**CARLISLE PUMP STATION DRAIN PIPE & POTRANCO ROAD INTERCONNECT**  
**Solicitation Number: CO-00253**  
**Job No.: 17-7003 and 18-6007**

**ADDENDUM 1**  
**April 9, 2019**

4'x4'x4' JUNCTION BOX  
STANDARDS (MOD)

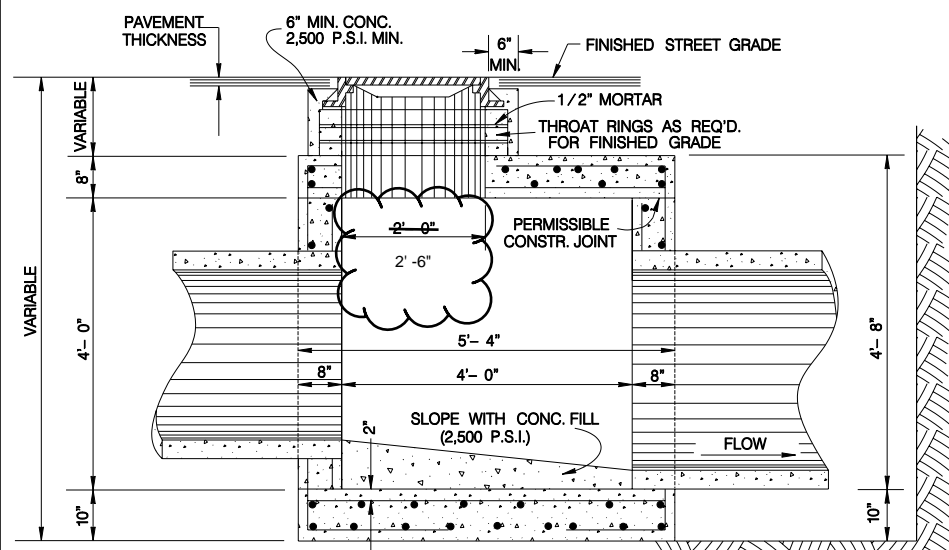
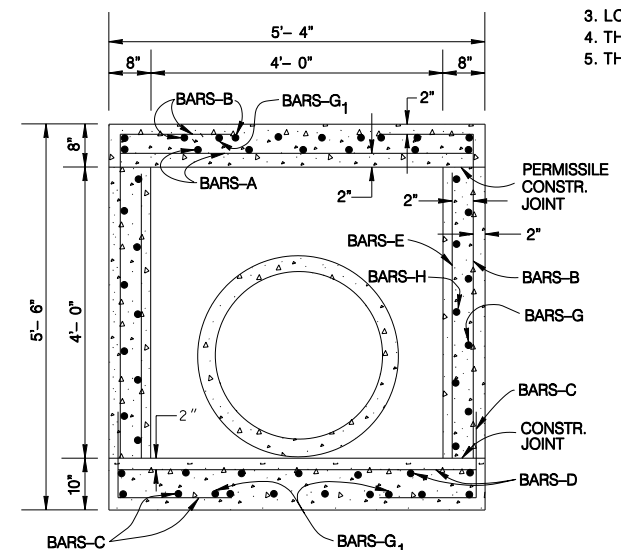
MODIFICATION - Revised Riser internal diameter to 2'-6" from 2'-0"
